Kirkland Parkplace Marketing Suite First Floor

KPP LOBBY DESIGN

FP-L01-TI

FIRE SPRINKLER PLAN 1/8'' = 1'-0

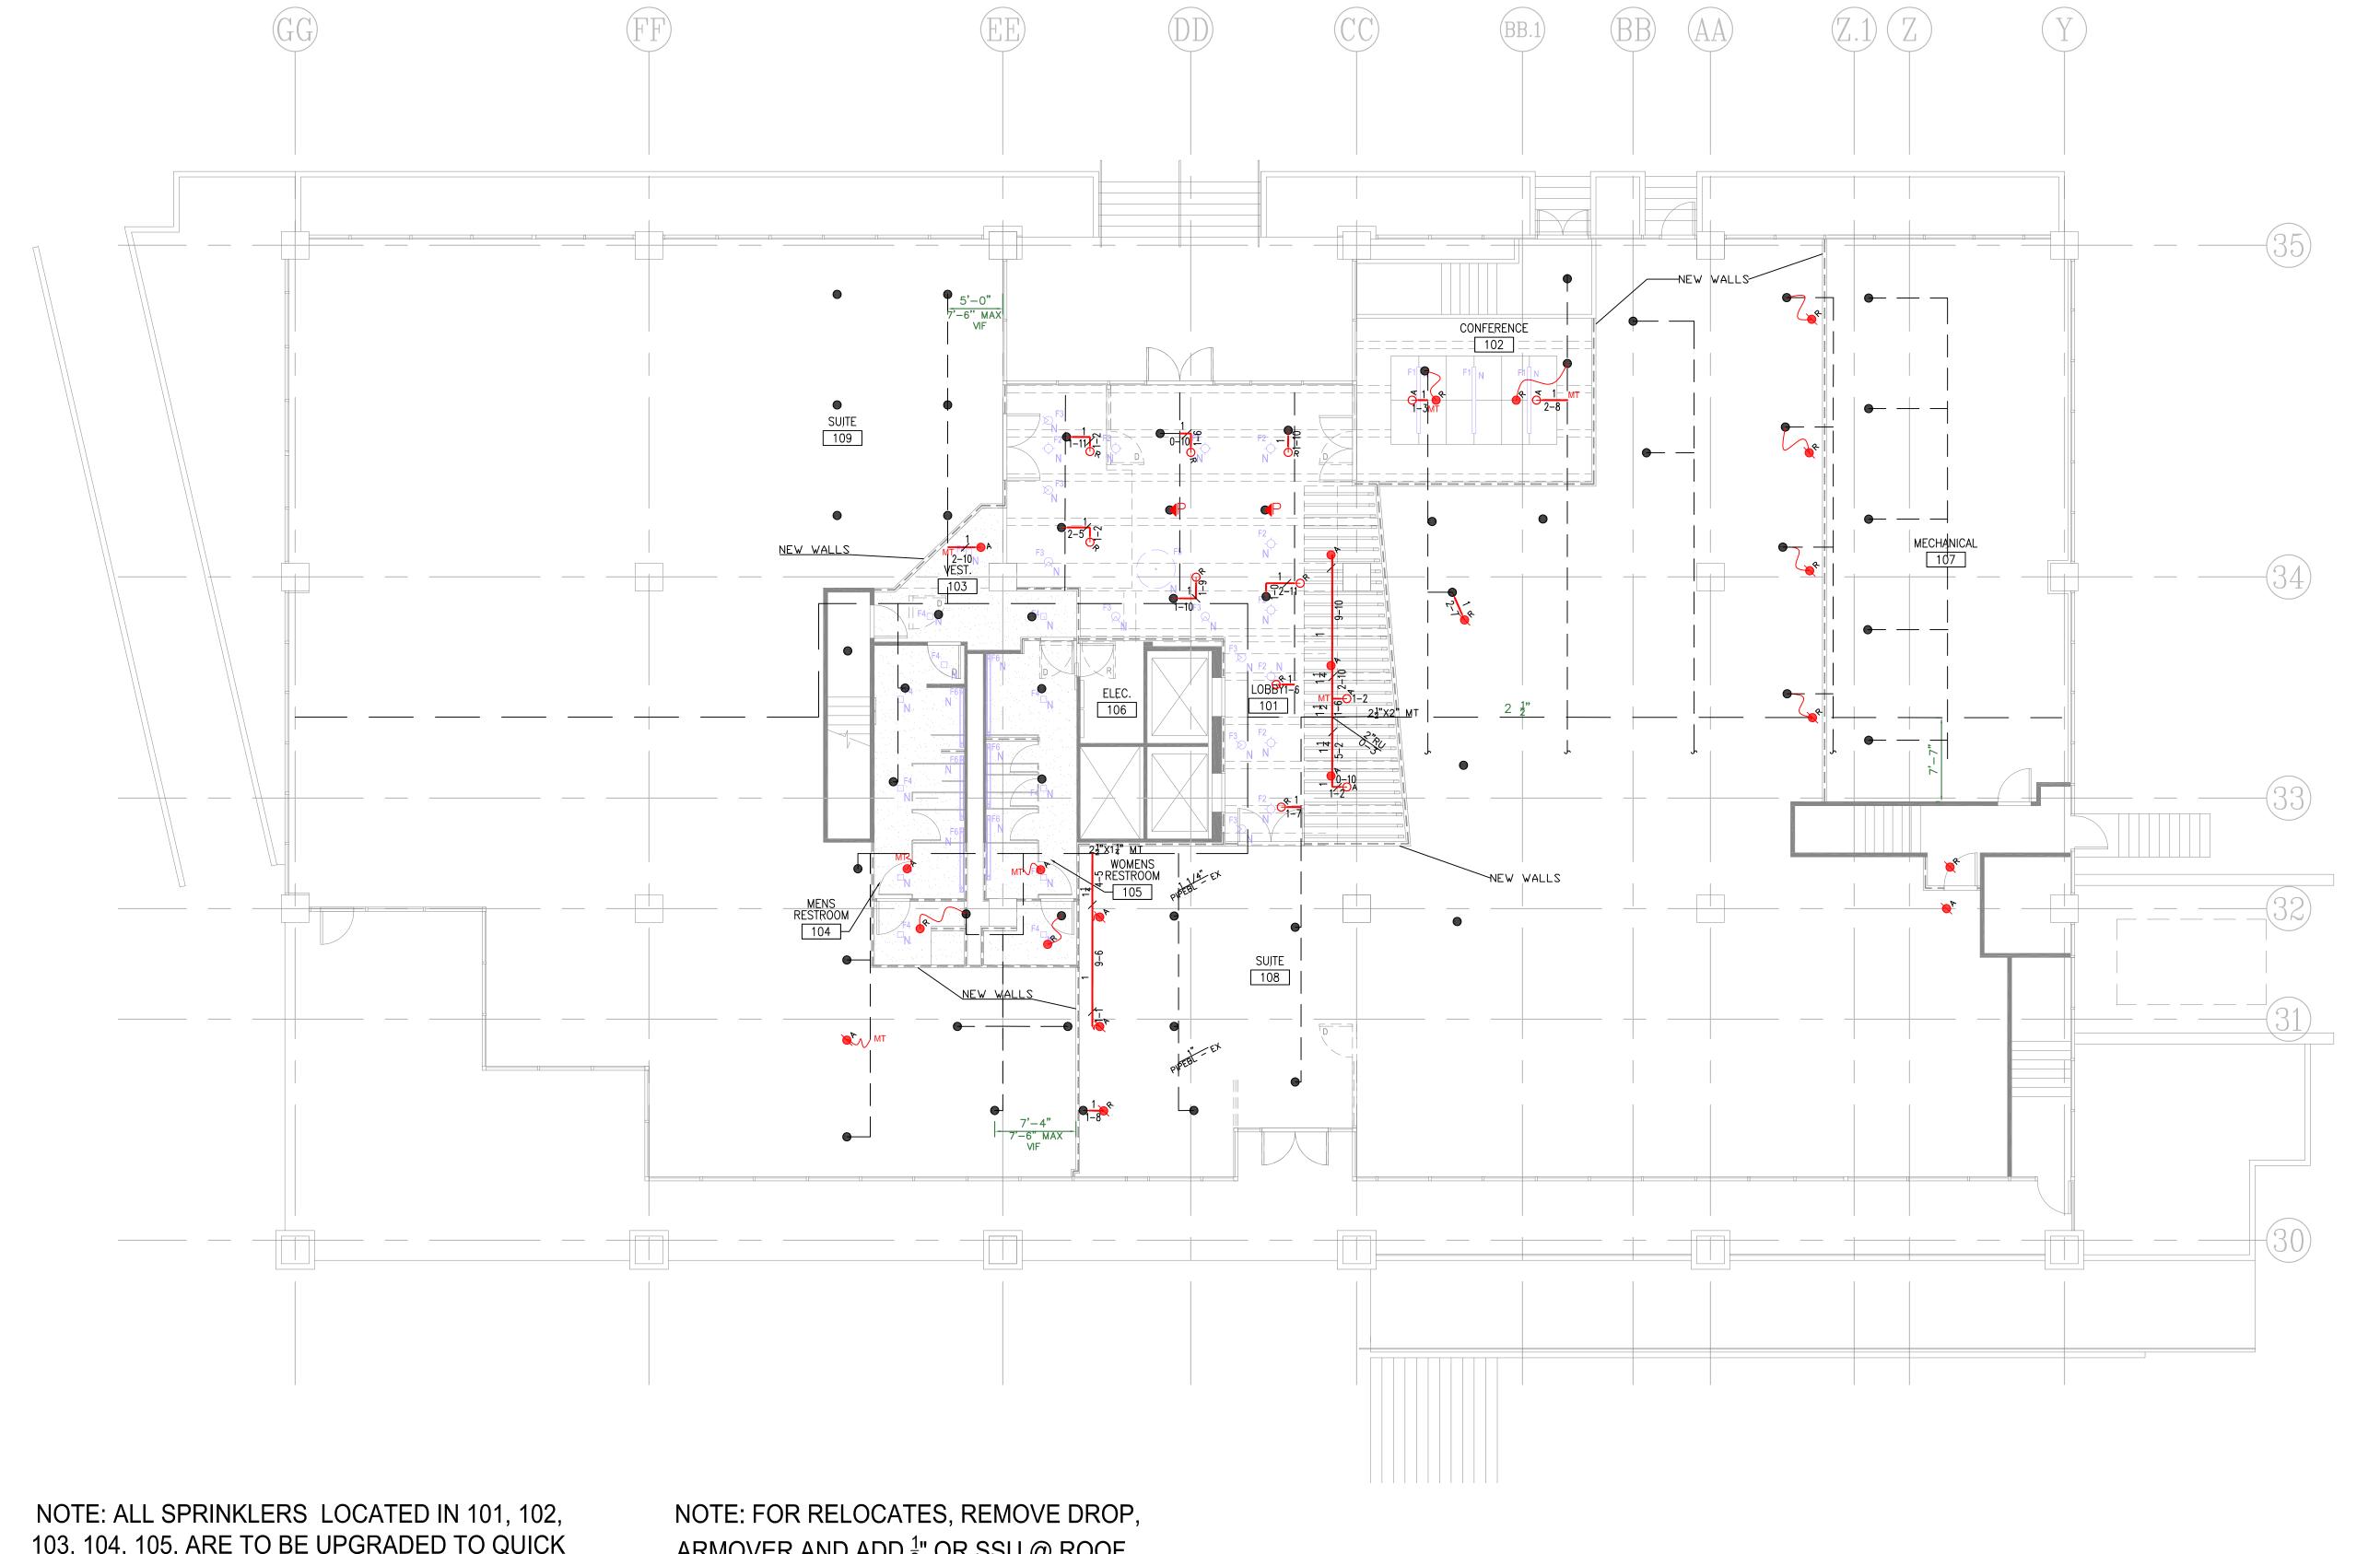
103, 104, 105, ARE TO BE UPGRADED TO QUICK RESPONSE, 155°F, 5.6K PENDENT AND UPRIGHT SPRINKLERS. (25 TOTAL)

ARMOVER AND ADD $\frac{1}{2}$ " QR SSU @ ROOF STRUCTURE. (TYP. IN OPEN STRUCTURE AREA)
